Report on Review of Bay Delta Conservation Program Modeling

Since December 2012, MBK Engineers and Dan Steiner (collectively “Reviewers”) have assisted various parties in evaluating the operations modeling that was performed for the Bay Delta Conservation Plan (BDCP). To assist in understanding BDCP and the potential implications, stakeholders¹ requested that the Reviewers review the CalSim II modeling studies performed as part of the BDCP (hereafter “BDCP Studies” or “BDCP Model”).

Figure 1. Projected Inflow to Trinity, Shasta, Oroville, and Folsom Reservoirs – NAA, NAA-ELT and NAA-LLT

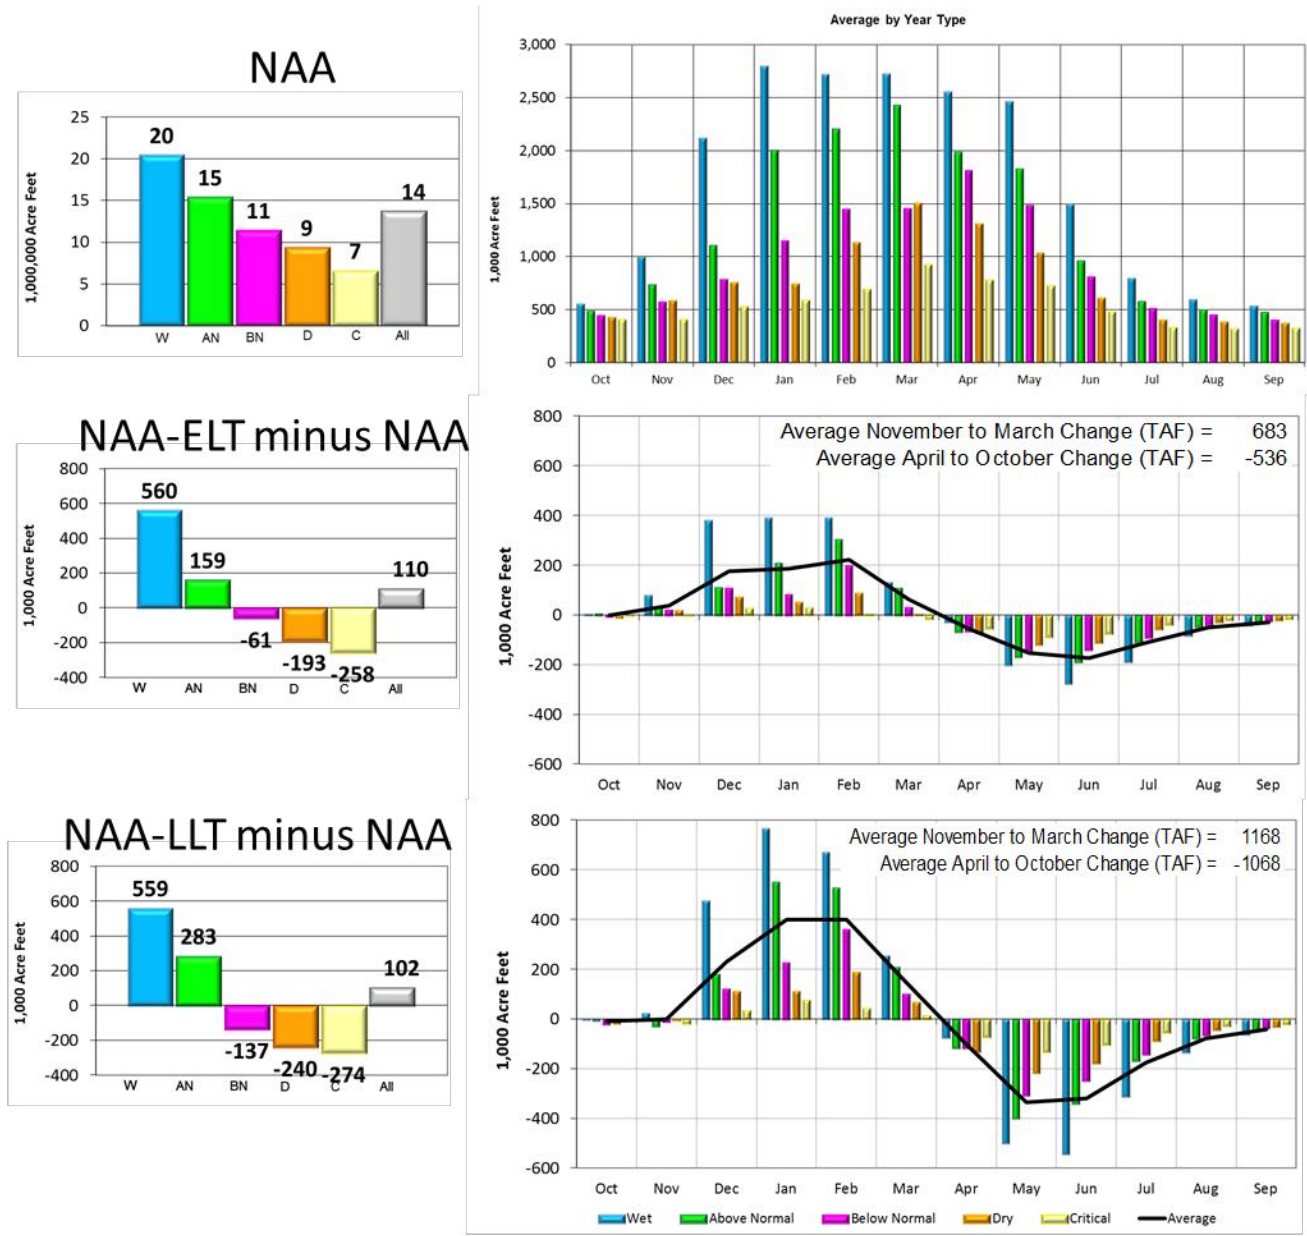
The significance of changed hydrology between the three without project baselines is illustrated in Figure 1 below. The figure illustrates the projected combined inflow of Trinity, Shasta, Oroville, and Folsom Reservoirs under the three NAA baselines. Numerous modeling projections for climate change have been developed, and in this BDCP group of Scenarios Trinity, Shasta, and Oroville inflow are projected to increase overall, but with a

In our opinion, the CalSim II depicted operations that incorporate climate change are not reasonably foreseeable and do not represent a likely future operation of the CVP/SWP. Although an argument is typically made that these study baselines will be used in a comparison analysis with Project Alternatives tiering from these baselines, we believe that the depicted operations do not represent credible CVP/SWP operations and we have no confidence in the results and they are inappropriate as the foundation of a Project Alternative. As such, although the modeling approach may provide a relative comparison between equal foundational operations, we are apprehensive to place much confidence in the computed differences shown between the NAA and Project Alternative Scenarios.

Figure 2. Projected Shasta Reservoir Carryover Storage, NAA, NAA-ELT and NAA-LLT

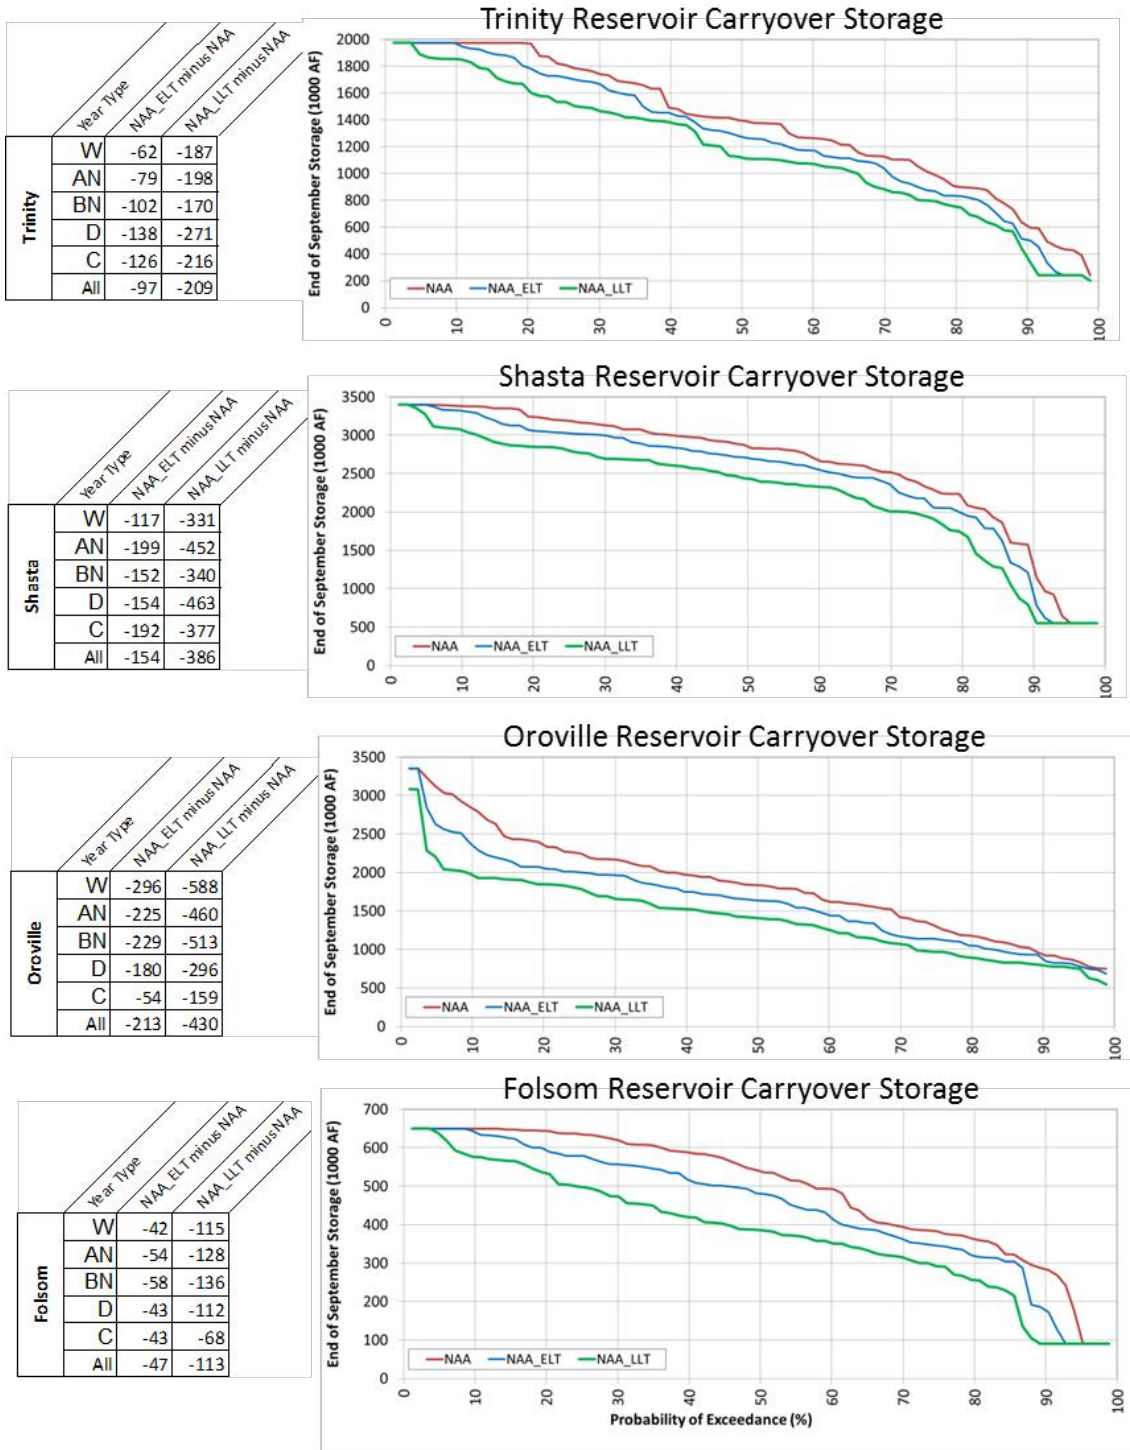
For upstream CVP and SWP reservoirs the assumed shift of inflows due to climate change (Figure 1) along with a continuing need to satisfy exports demands significantly affects carryover storage. The CVP and SWP simply cannot satisfy water demands and regulatory criteria imposed on them in the NAA-ELT and NAA-LLT modeling scenarios.

Figure 2 illustrates the typical change in carryover storage as shown for Trinity, Shasta, Oroville, and Folsom Reservoirs. The relatively high frequency (approximately 10% of time) of minimum storage occurring at CVP reservoirs illustrates our questioning of credible operations in the studies.

Figure 3. Projected Inflow to Millerton Lake –NAA, NAA-ELT and NAA-LLT

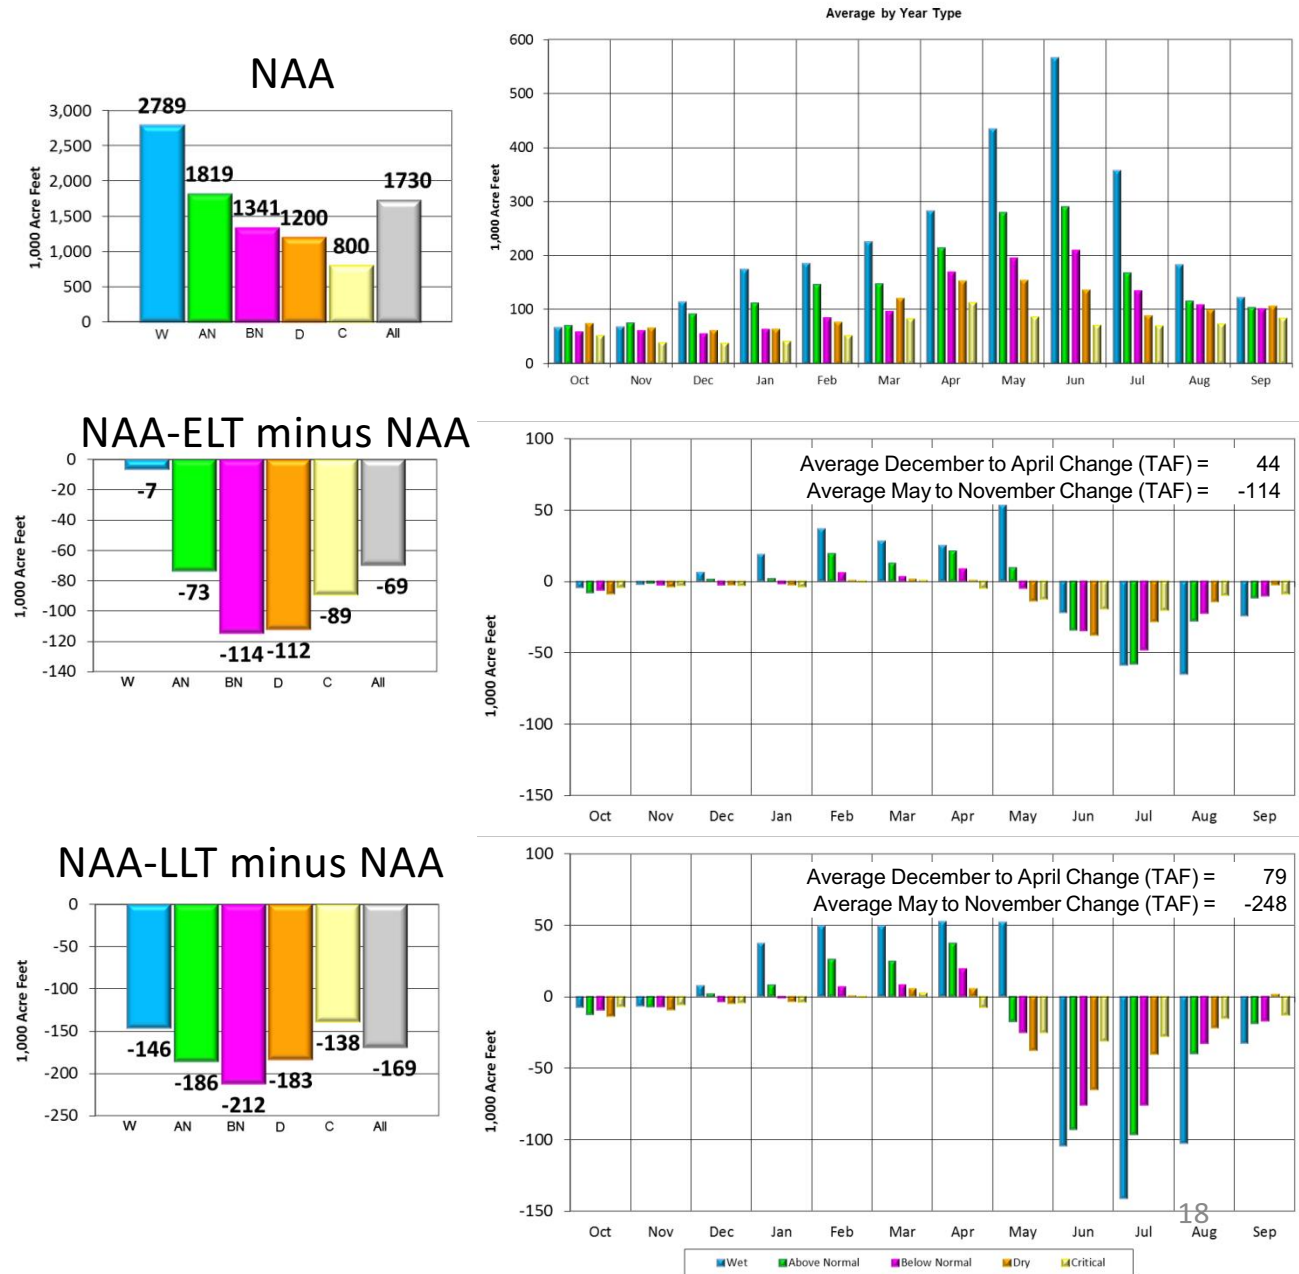
San Joaquin Valley reservoirs are depicted with an overall decrease in annual runoff with some shifting of runoff from spring to winter, but mostly just decreases in spring runoff due to a decline in snowmelt runoff during late spring⁵. Figure 3 illustrates the assumed effects of climate change upon inflow to Millerton Lake.

The hydrology differences imposed in the NAA Scenarios of the Friant Division are described above, and its appropriateness may be subject to additional debate and Alternative assumptions. However, our review found that implementation of Millerton Reservoir inflow as affected by climate change was improperly performed.

Inflow to Millerton Reservoir in this version of CalSim is input in three separate time series for purposes of depicting the hydrology of potential upper basin reservoirs. Climate change hydrology was inconsistently incorporated at Millerton Reservoir and misapplied to the water supply and flood control operations. The result is an unrealistic operation for river releases and canal diversions. Figure 3 illustrates the projected ELT and LLT changes in Millerton Reservoir inflow incorporated in these studies. On face value of the input data, regardless of Friant Dam river release assumptions the effect of climate change at Millerton Lake will affect water deliveries.

Figure 4. Millerton Reservoir Carryover Storage, NAA, NAA-ELT and NAA-LLT Scenarios

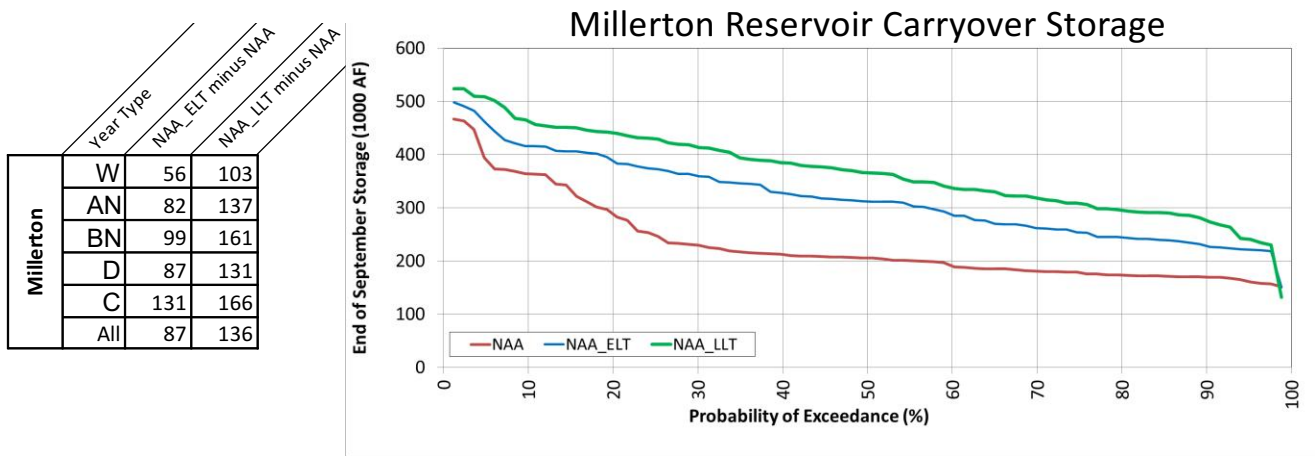
Evidence of the inconsistent inflow problem is shown in the result for the comparison of carryover storage of Millerton Reservoir under the NAA, NAA-ELT, and NAA-LLT Scenarios (Figure 4). Carryover storage is higher in the ELT and LLT Scenarios due to climate change effects to inflow incorporated in reservoir operations but not in the computation of water supply deliveries. Thus, water deliveries are suppressed and the reservoir ends the year with greater storage.

Figure 12. Temperature Exceedance Sacramento River at Bend Bridge Existing, No Action Alternative, ELT

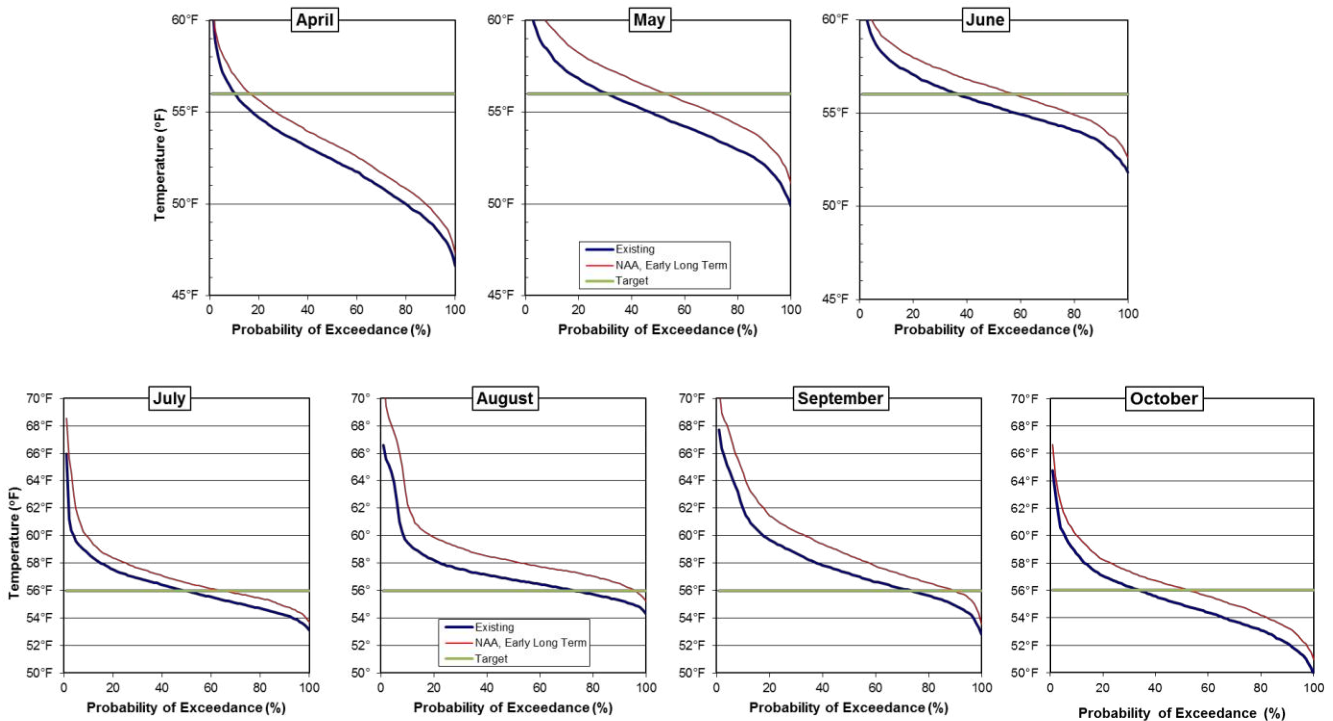
The increase in equilibrium temperatures combined with decreases in storage would lead to water temperature conditions that would likely not achieve the assumed objectives. Figure 12 and Figure 13 illustrate an increase in the probability that a water temperature target of 56°F would be exceeded at Bend Bridge under both the NAA-ELT and NAA-LLT Scenarios. The probability of exceedance increases approximately 5% to 20% depending on the month for the NAA-ELT Scenario and approximately 10% to 40% for the NAA-LLT Scenario.

Figure 19. NDD, Bypass Requirement, Bypass Flow, and Excess Sacramento R. flow for Alt 4-ELT

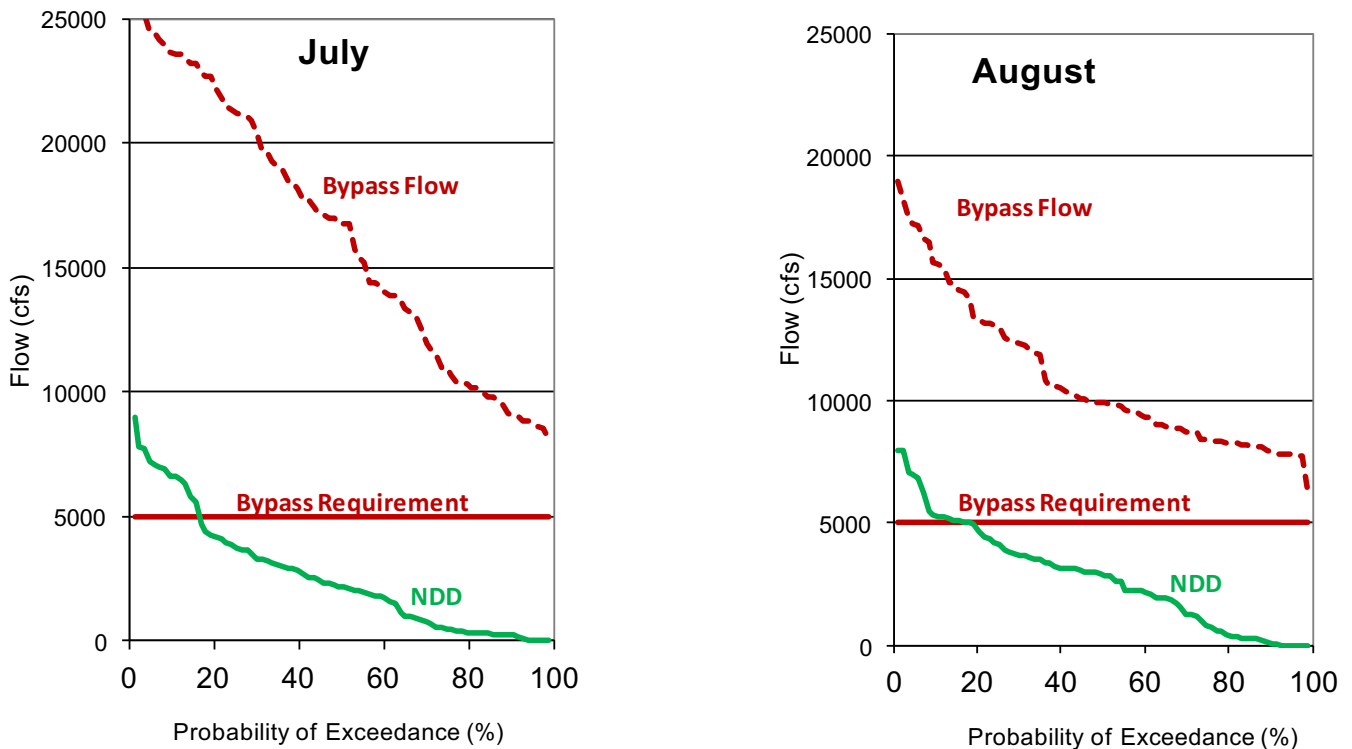
Sacramento River flow below the North Delta Diversion (NDD) must be maintained above the specified bypass flow requirement, therefore the NDD rates are limited to the Sacramento River flow above the bypass requirement. Due to an error in CalSim II that specifies an unintended additional bypass requirement, modeling performed for the BDCP EIRS often bypasses more Sacramento River flow than is specified in the BDCP project description. This error has been fixed in the most recent public releases of CalSim II, but BDCP modeling has not been updated to reflect these fixes. Figure 19 contains exceedance probability plots showing the Sacramento River required bypass, Sacramento River bypass flow, NDD, and excess Sacramento River flow to the Delta as modeling for BDCP. As can be seen in Figure 19, the bypass flow is always above the bypass requirement in July and August. The BDCP version of CalSim sets a requirement for Sacramento River inflow to the Delta needed to satisfy all Delta flow, quality, and export requirements, this requirement should be removed when modeling the NDD.

Figure 22. Alt 4-ELT North Delta Diversion Versus South Delta Diversion for July, August, and September

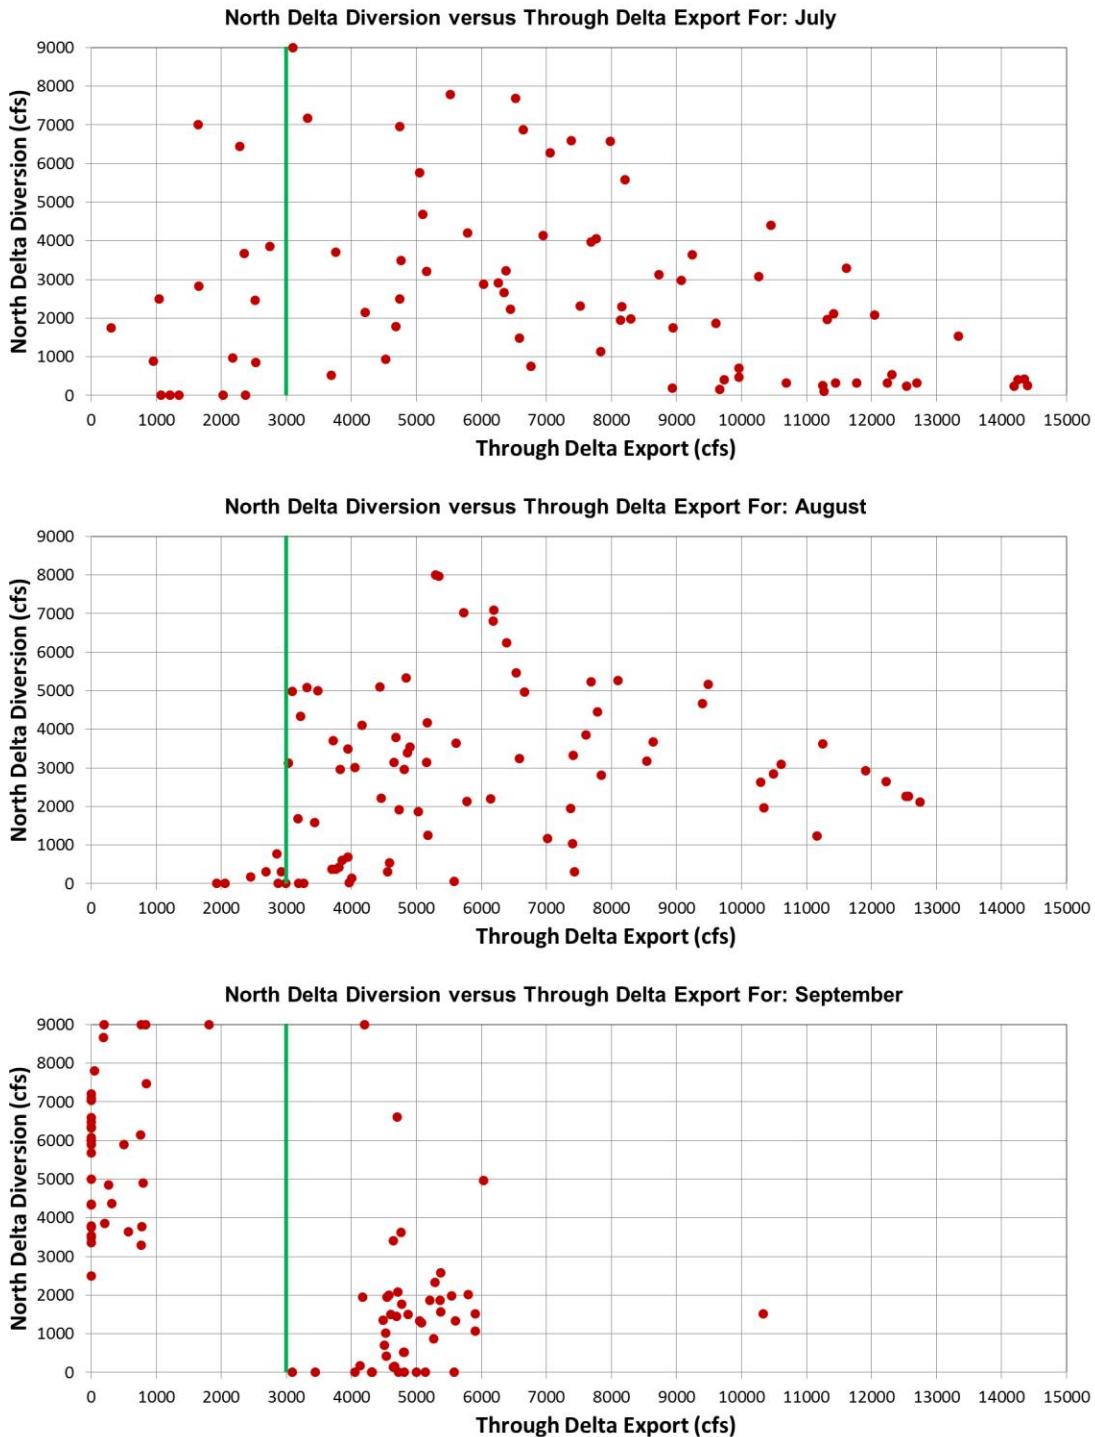
Figure 22 contains figures for July, August, and September for Alt 4-ELT that plot NDD against SDD. In the months of July to September SDD are occasionally very high, exceeding 14,000 cfs in July, with minimal NDD. This occurs due to outdated model code that imposes an instream flow requirement in Sacramento River flow below Hood in excess of the bypass criteria prescribed in the BDCP. There are numerous occurrences when bypass flows prescribed in the BDCP are exceeded and SDD are higher than expected. On the other hand, there are also many times when NDD are above minimum pumping levels and SDD are below the BDCP prescribed 3,000 cfs threshold indicated by the green line in Figure 22. For unknown reasons, the model code requiring SDD to be greater than 3,000 cfs before NDDs occur from July through September is deactivated in the BDCP modeling of this Alternative.
